**CONTRACT ADDENDUM #**

**date:** 5.10.24  
**project:** Nibley Middle School  
**by:** Michael Rigby  
**subject:** Addendum 02

Clarification and changes from Bid Package 1 to Bid Package 2. Includes update to the concrete openings, structural items – see structural narrative, and civil items – see civil narrative.

**SUBJECT:** Addendum #2 – Changes to Bid Package #1

FOOTING AND FOUNDATION PLAN - AREA C

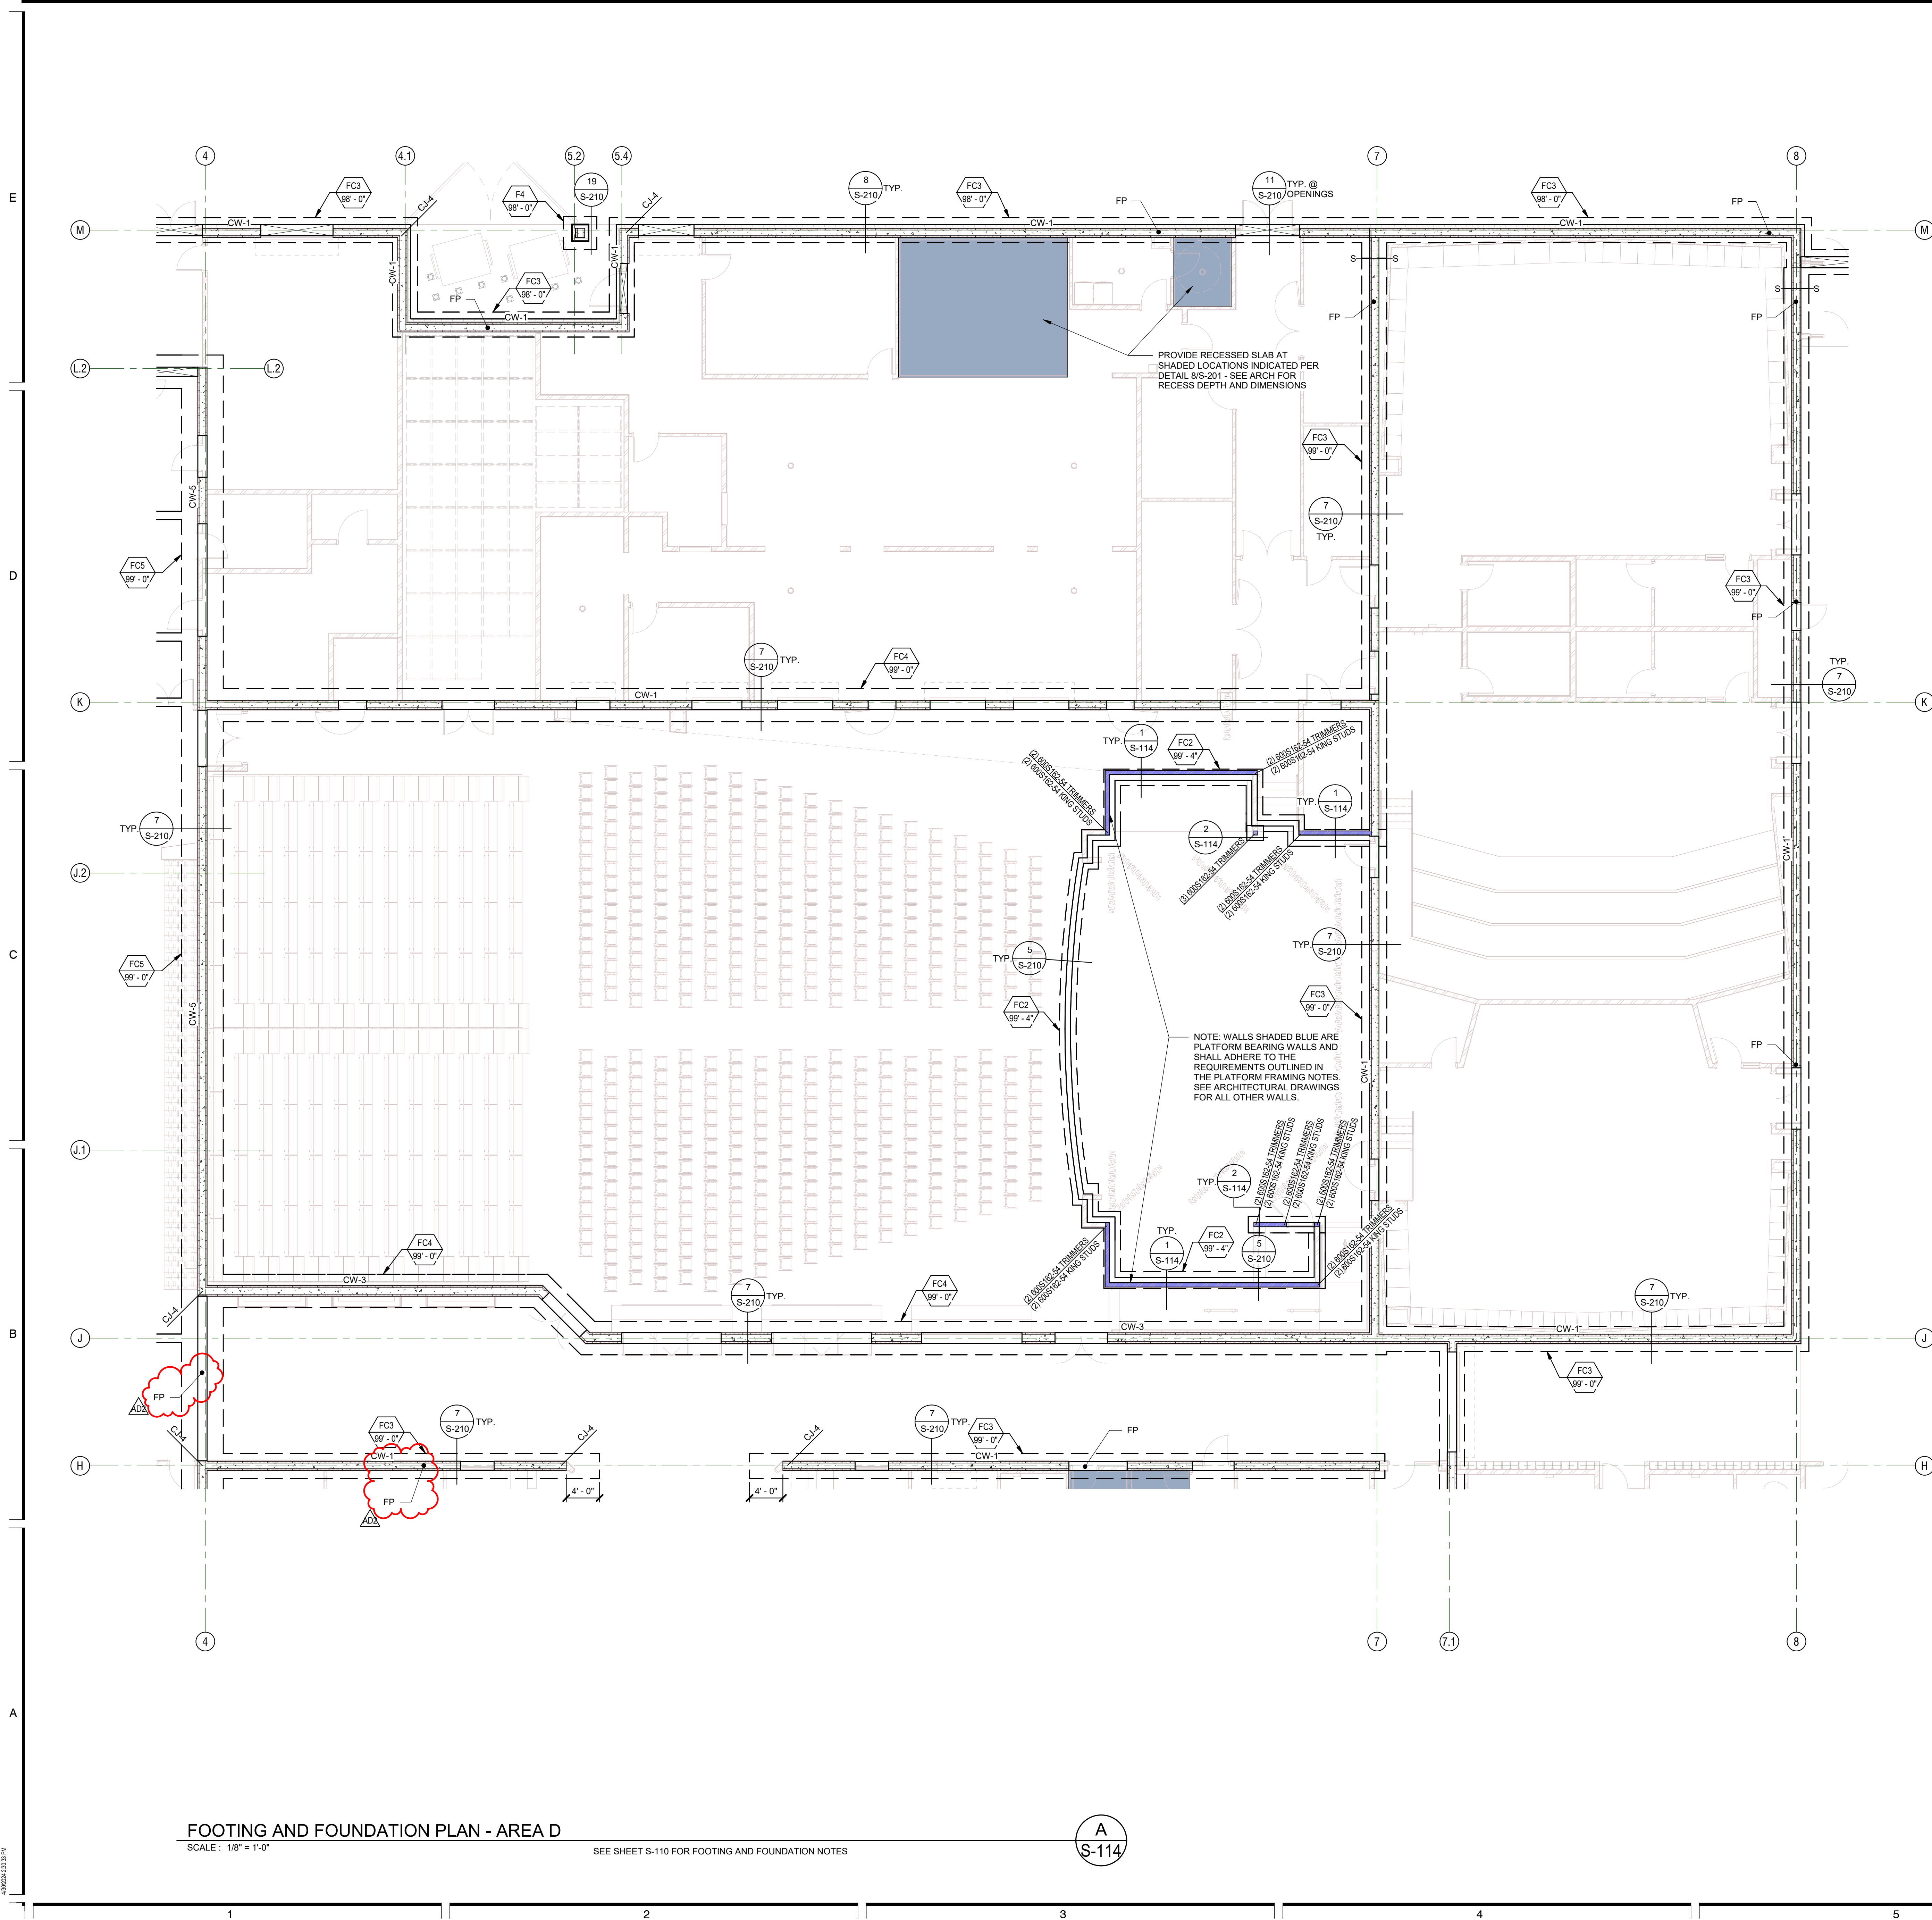
- 1) The mechanical yard footings were revised.
- 2) Additional potential foundation penetrations ("FP") locations were noted.
- 3) Door location revisions have been shown.

**FOOTING AND FOUNDATION PLAN - AREA D**  
SCALE: 1/8" = 1'-0"  
SEE SHEET S-110 FOR FOOTING AND FOUNDATION NOTES

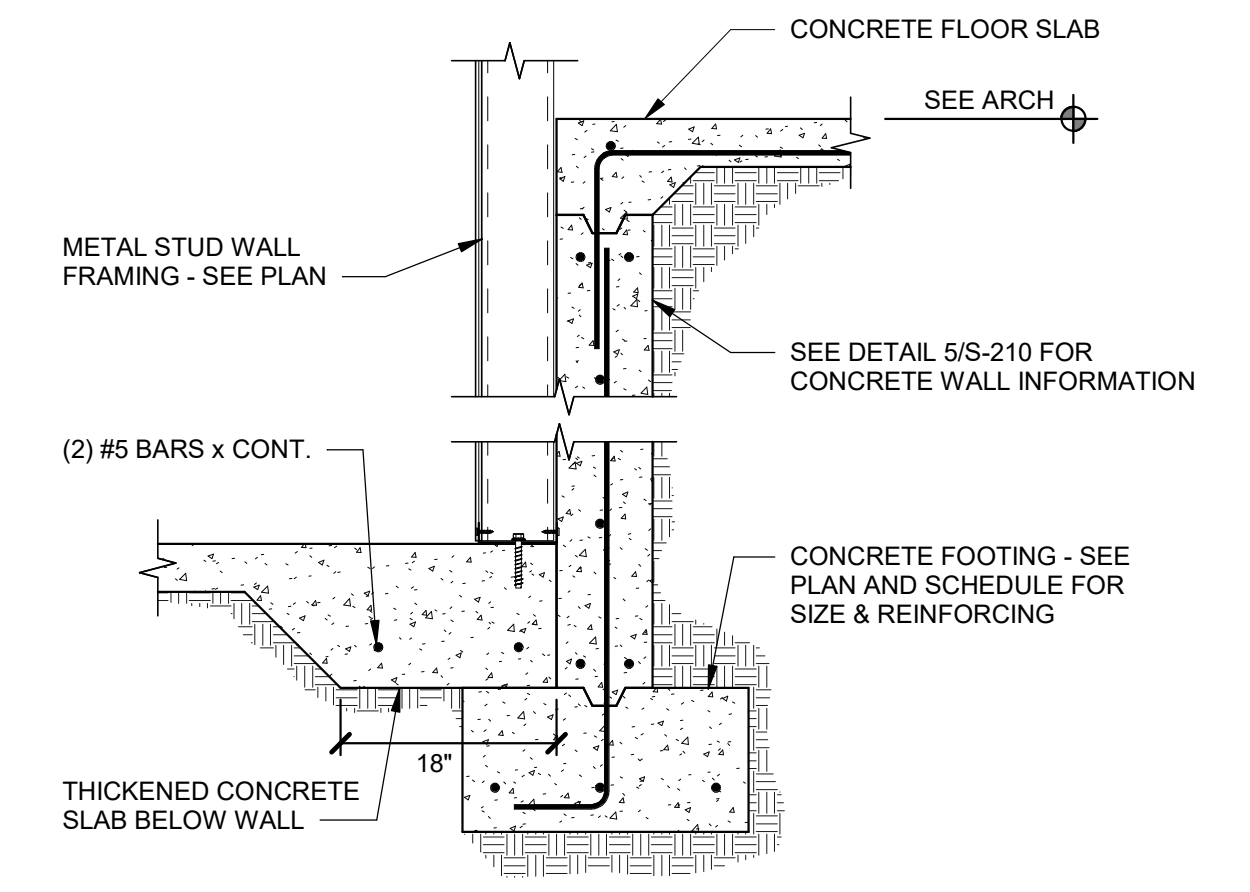
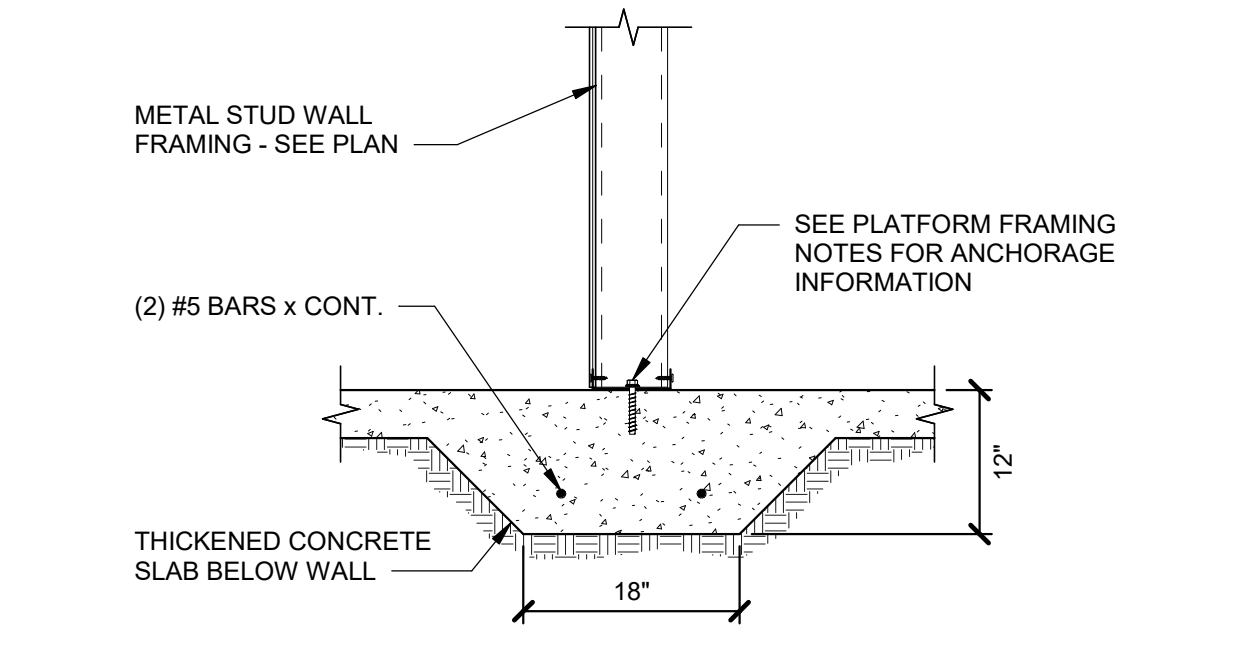
- 1) Additional potential foundation penetrations ("FP") locations were noted.
